FORD:

2015-2016 Mustang

TSB 15-0144 (Continued)

Figure 1 - Article 15-0144

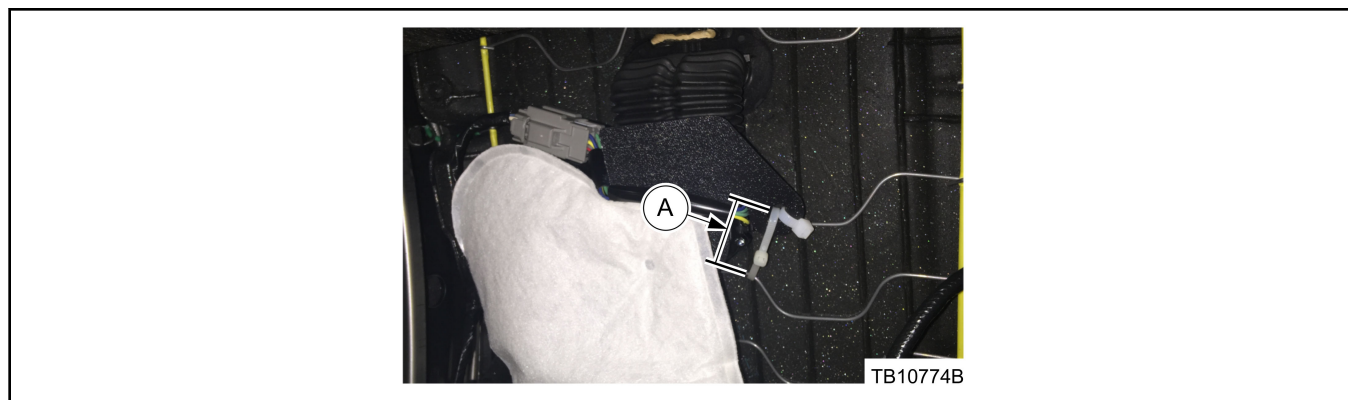
1. Perform the procedure on both seats.
2. Does the vehicle exhibit a lack of cooling from the front seat backrest when using the climate controlled seat?
 - a. Yes - proceed to Step 3.
 - b. No - this article does not apply. Refer to Workshop Manual (WSM), Section 501-10 for normal diagnostics.
3. Can the front seat backrest blower motor be heard running when using the climate controlled seats?
 - a. Yes - proceed to Step 4.
 - b. No - this article does not apply. Refer to WSM, Section 501-10 for normal diagnostics.
4. Remove the front seat backrest blower motor. Refer to WSM, Section 501-10.
5. Install a new front seat backrest blower motor. Refer to WSM, Section 501-10.
 - a. Secure the new front seat backrest blower motor with a tie strap leaving 25 mm (1 inch) of slack in the tie strap. (Figure 1A)

Figure 2 - Article 15-0144

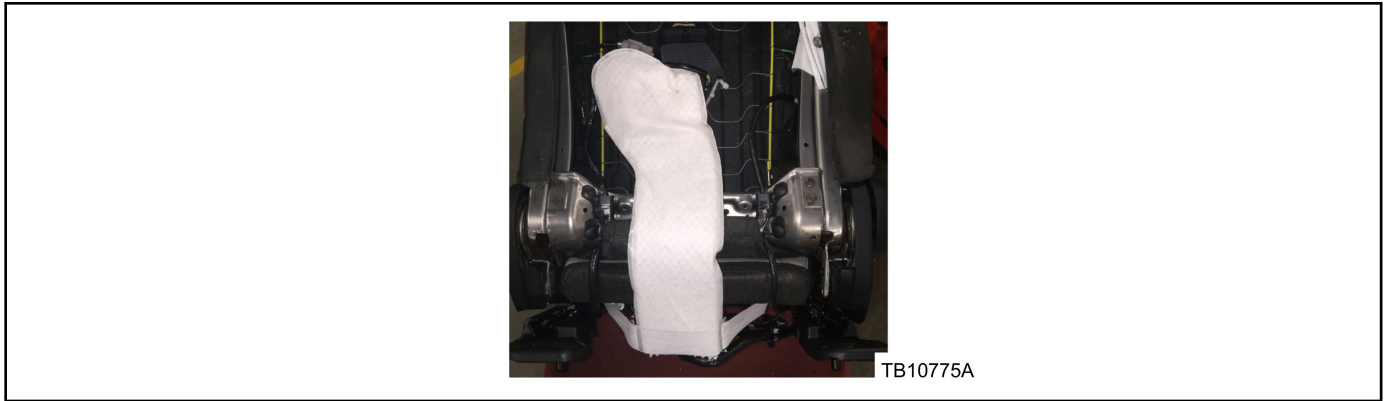
- b. Route the air intake snorkel of the new blower motor as shown. (Figure 2)

Figure 3 - Article 15-0144

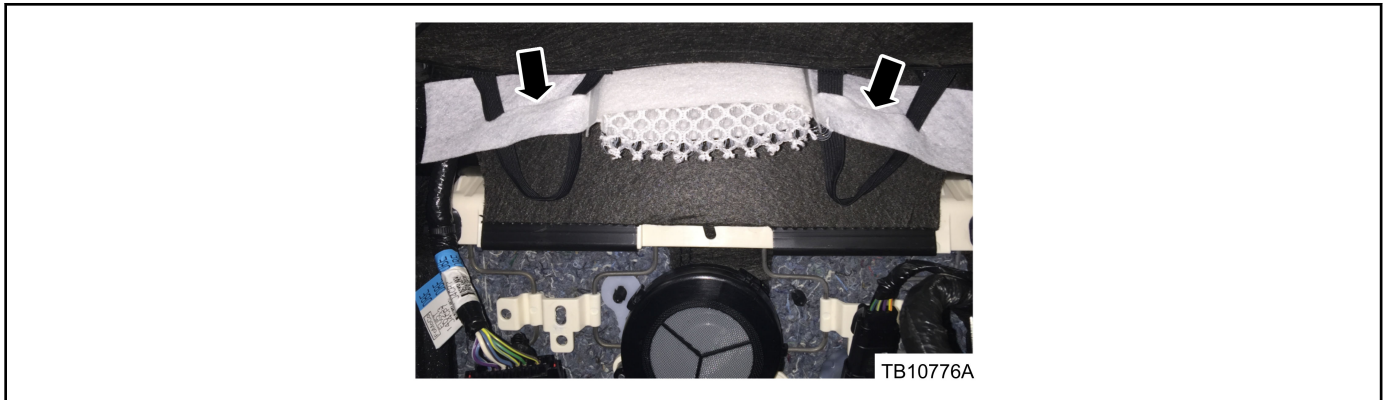
- 6. Reinstall the seat backrest cover. Refer to WSM, Section 501-10.
 - a. Route the elastic backrest cover straps through the slots in the fabric at the end of the air intake snorkel prior to refastening the elastic backrest cover straps. (Figure 3)
